METROPOLITAN GOVERNMENT OF NASHVILLE AND DAVIDSON COUNTY

STAFF RECOMMENDATION
198 Manchester Avenue
May 20, 2015

Application: New construction-infill; Setback determination
District: Eastwood Neighborhood Conservation Zoning Overlay
Council District: 06
Map and Parcel Number: 08306013900
Applicant: Brad Sayers
Project Lead: Paul Hoffman, paul.hoffman@nashville.gov

Description of Project: The applicant proposes new construction of a single-family residence and detached outbuilding. The outbuilding is not a detached accessory dwelling unit. A setback determination is requested for the left side of the infill, from five feet (5') to three feet, six inches (3'6"), due to a sewer easement.

PLOT PLAN

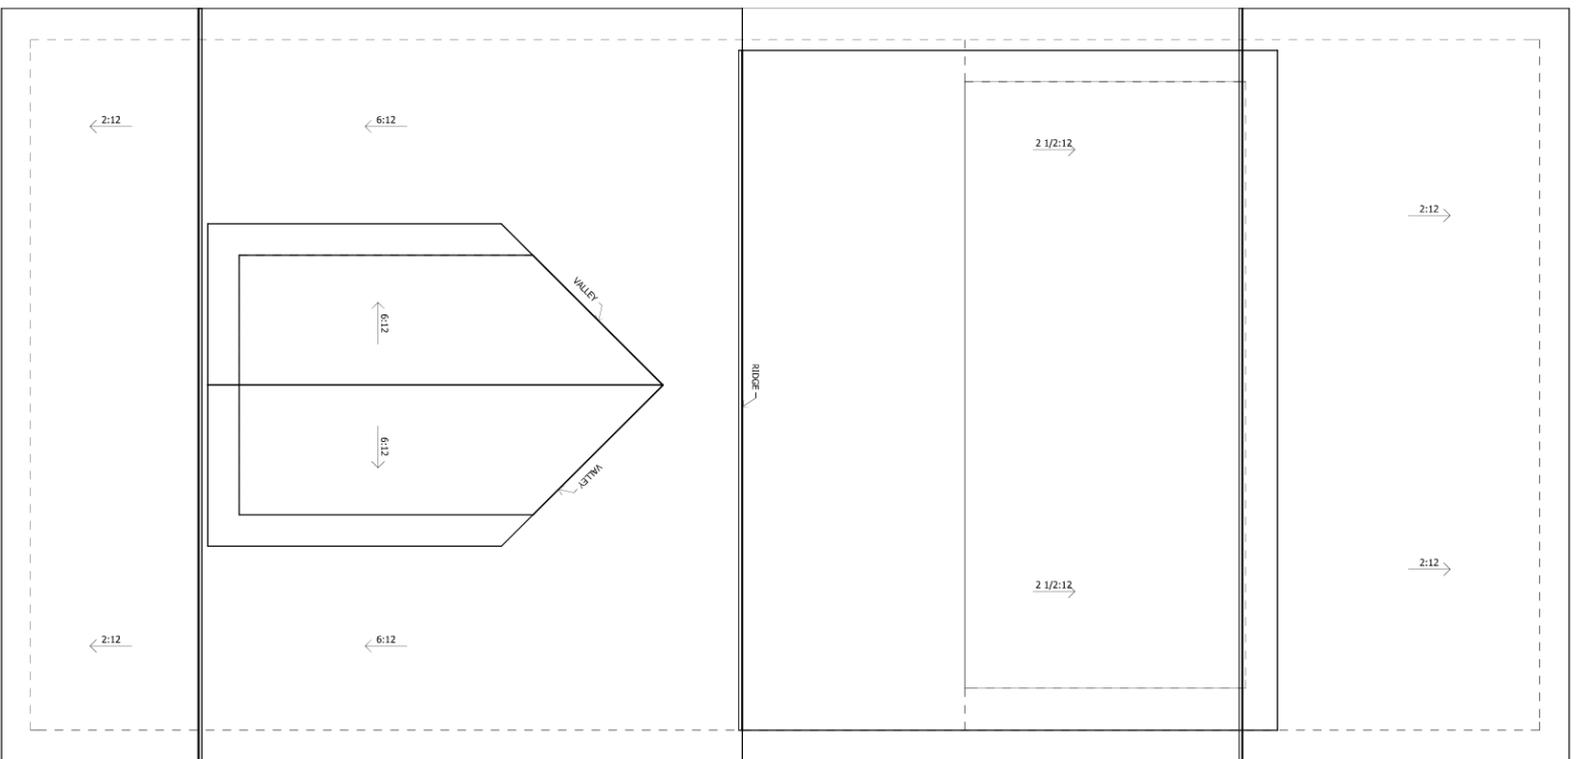
Setback & Rhythm of Spacing: The building's front setback from its porch will be thirty-two feet, nine inches (32'9"), the average of the adjoining historic buildings, and is compatible with other historic houses nearby. The rear setback is approximately sixty feet (60'), meeting the required twenty feet (20'). The side setbacks are fourteen feet, eight inches (14'8") on the right and three feet, six inches (3'6") on the left. The setback on the right meets the required five feet (5') setback of bulk zoning. The setback determination for the left side is based on a sewer easement of twenty feet (20') on the right side. For this reason, Staff recommends the setback determination, and finds that the project meets section II.B.1.c.

Outbuildings: As submitted, the outbuilding does not meet the design guidelines for height and scale. The proposed footprint of six hundred seventy-two square feet (672 sq. ft.) is too large for a two-story outbuilding. A two-story outbuilding may have a footprint up to five hundred and fifty square feet (550 sq. ft.). The outbuilding also should have an eave height no higher than that of the house, which averages ten feet, six inches (10’6”). Staff recommends disapproval of the outbuilding as submitted. A revised outbuilding that meets the design guidelines may be approved administratively at a later date. See attached outbuildings worksheet for more details on Staff’s review.

Staff recommends disapproval of the proposed outbuilding, finding that it does not meet the design guidelines. The applicant may submit a revised design that meets the guidelines for administrative approval.

ELEVATIONS

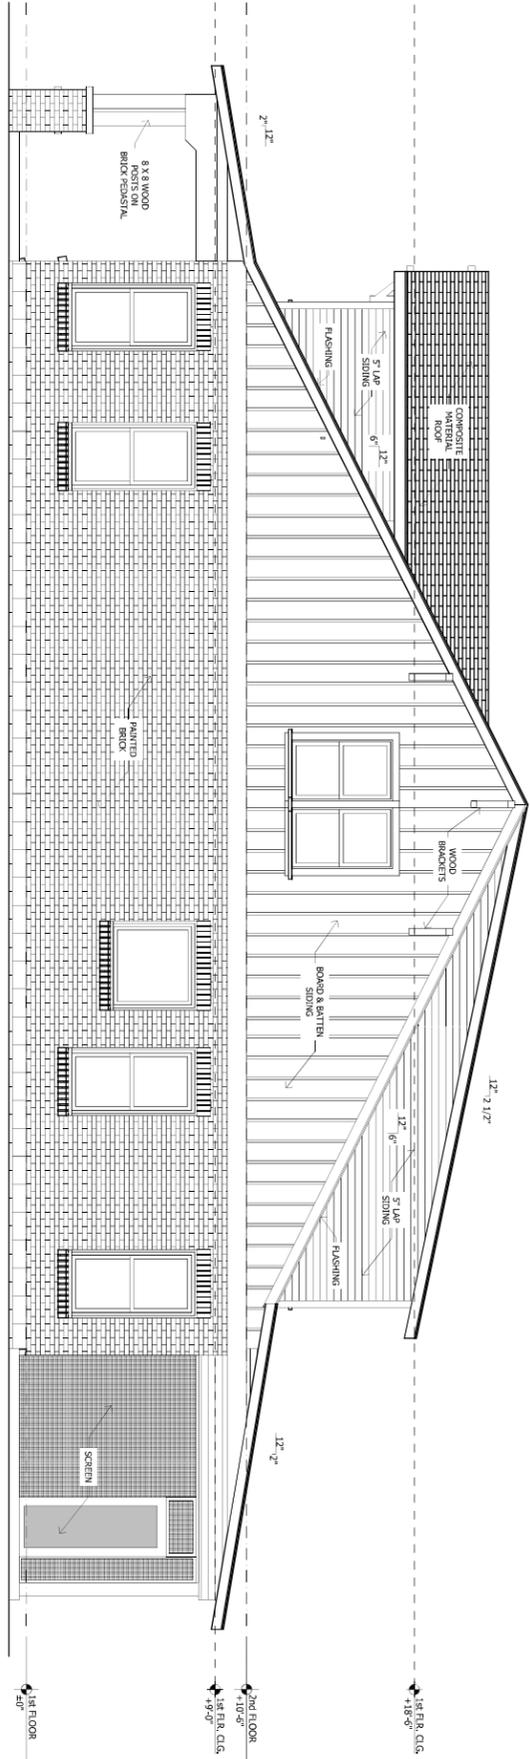
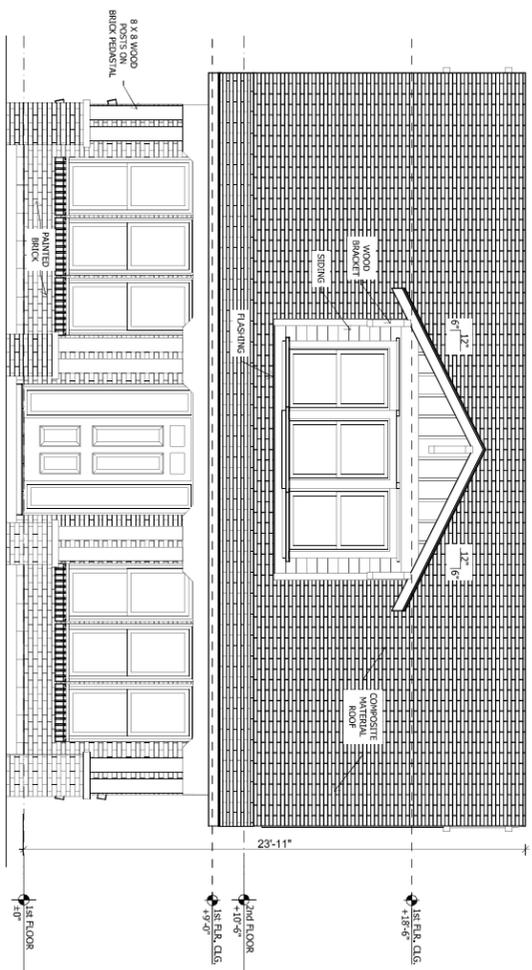
Height & Scale: The proposed building will be one and one-half stories and approximately twenty-four feet (24') from the finished floor height. The foundation height as drawn is only one block high. As this is an unlikely final foundation height, Staff requests the applicant verify the intended foundation height, as well as the grade of the lot, which appears to drop approximately four feet (4') from the front of the lot to the back. The foundation heights of nearby contributing houses are from one to three feet (1'-3'). Assuming a final foundation height of up to three feet (3'), the building's overall height of twenty-seven feet (27') is compatible with the context, which is between nineteen and twenty-nine feet (19'-29').

Staff finds the height and scale will be compatible with surrounding historic buildings. With the condition that the foundation height and the grade of the lot are revised on the elevations, the project meets sections II.B.1.a. and b.

Proportion and Rhythm of Openings: The majority of the windows are approximately twice as tall as they are wide. There is one expanse of approximately nineteen feet (19’) on the building’s right side with no window or door openings. In this location, Staff finds the condition acceptable, as the neighboring house on that side will be close, approximately ten feet (10’) away, and visibility will be limited. Staff finds the project’s proportion and rhythm of openings to meet Section II.B.1.g.

1. Elevations be revised to depict the site's grade and the new building's actual intended foundation height;
2. The finished floor height shall be consistent with the finished floor heights of the adjacent historic houses, to be verified by MHZC staff in the field;
3. Staff approve the final details, dimensions and materials of windows and doors prior to purchase and installation; and,
4. Staff approve the roof color and masonry color, dimensions and texture.
